PD Modification Application: PRS 26-0621 (Rev.)

Introduction Summary

AGENCY REVIEW COMMENT SHEET

PETITION NO: PRS 26-0621

2.5 Proposed Site Plan (partial provided below for size and orientation purposes. See Section 8.2 for full site plan)

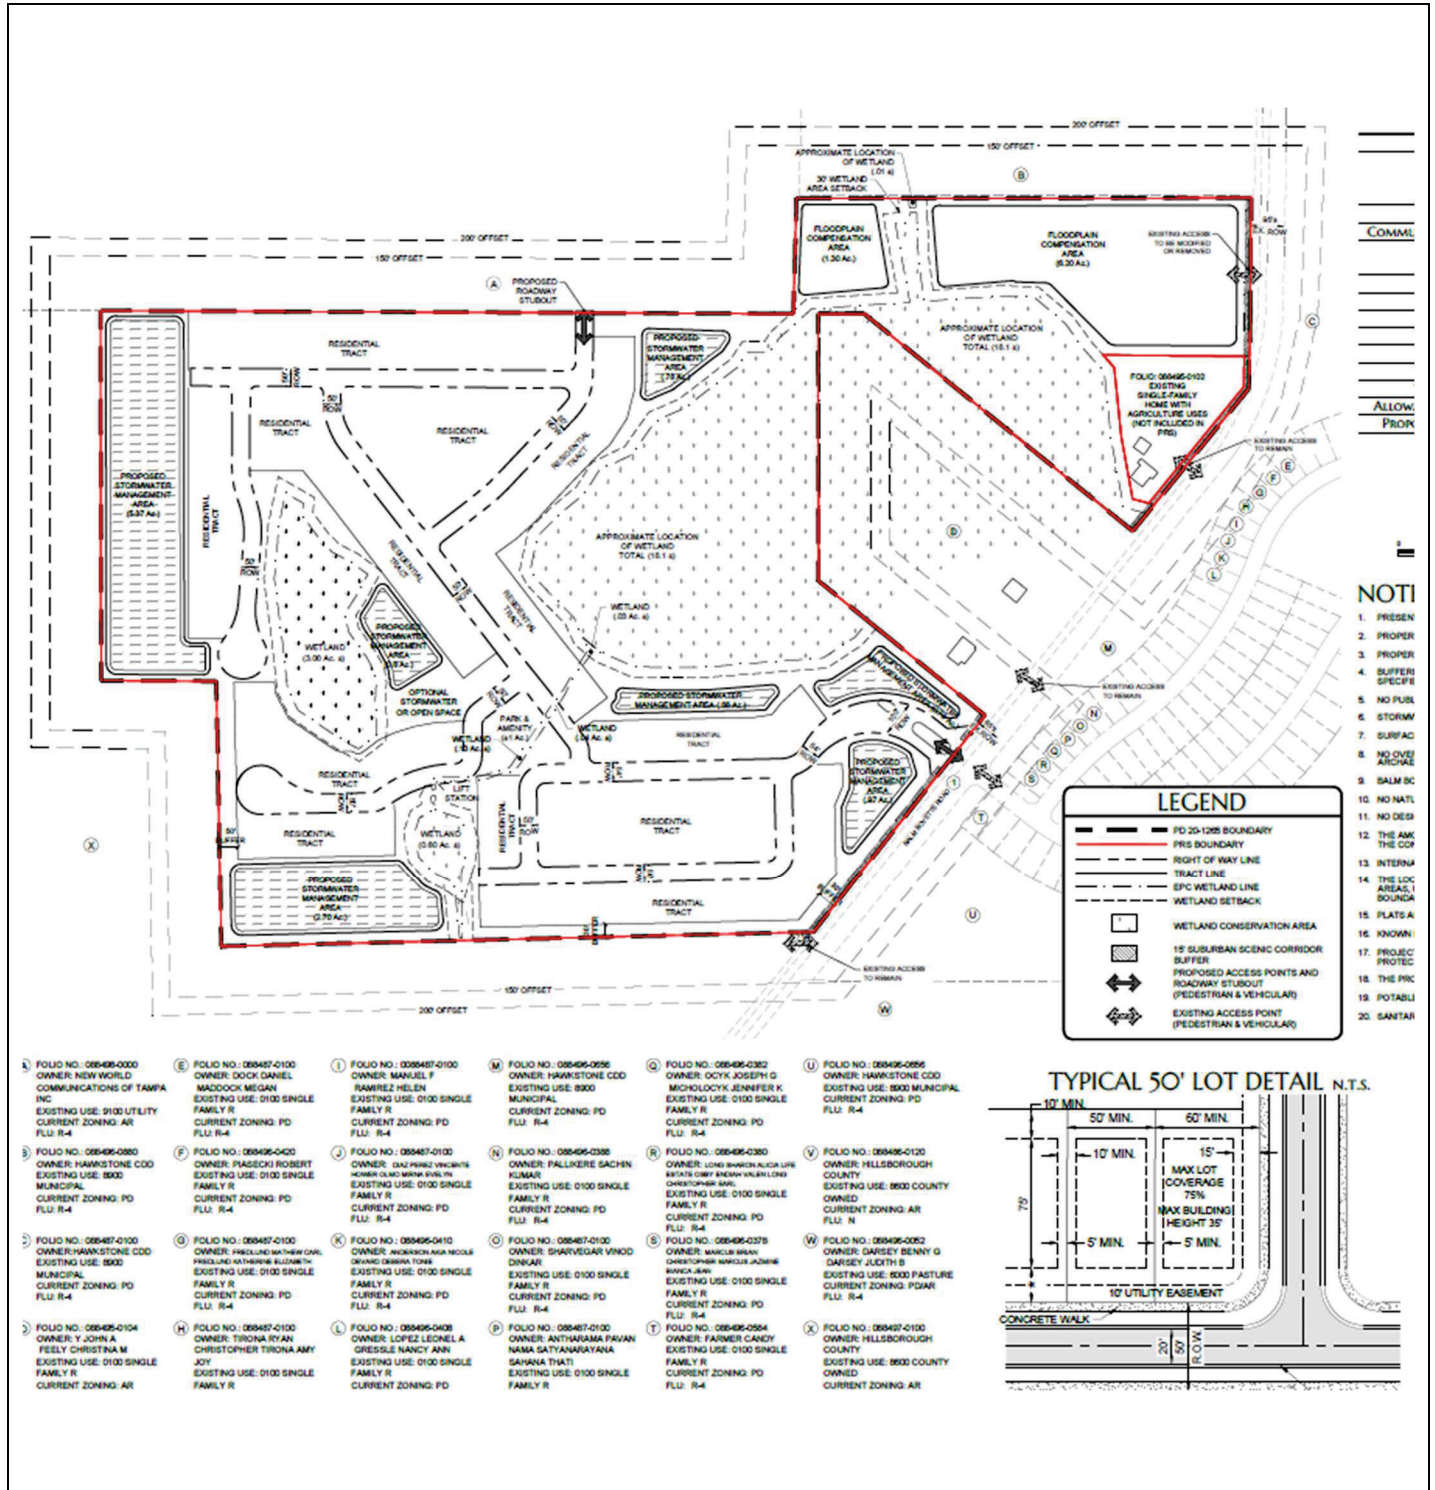
Along the project’s western and southern boundary, the previously approved vehicular and pedestrian roadway stubout is proposed to be removed. The adjacent property is County owned (ELAPP) lands and according to the County Conservation and Environmental Lands Management Department there are no plans to accommodate a future roadway.

SITE PLAN ERROR- RC field to the west and BMX track to the south are both part of the ELAPP Preserve, Conservation & Environmental Lands Management Dept. There is no accomodation for a roadway into the Preserve from this development as indicated on the site plan.
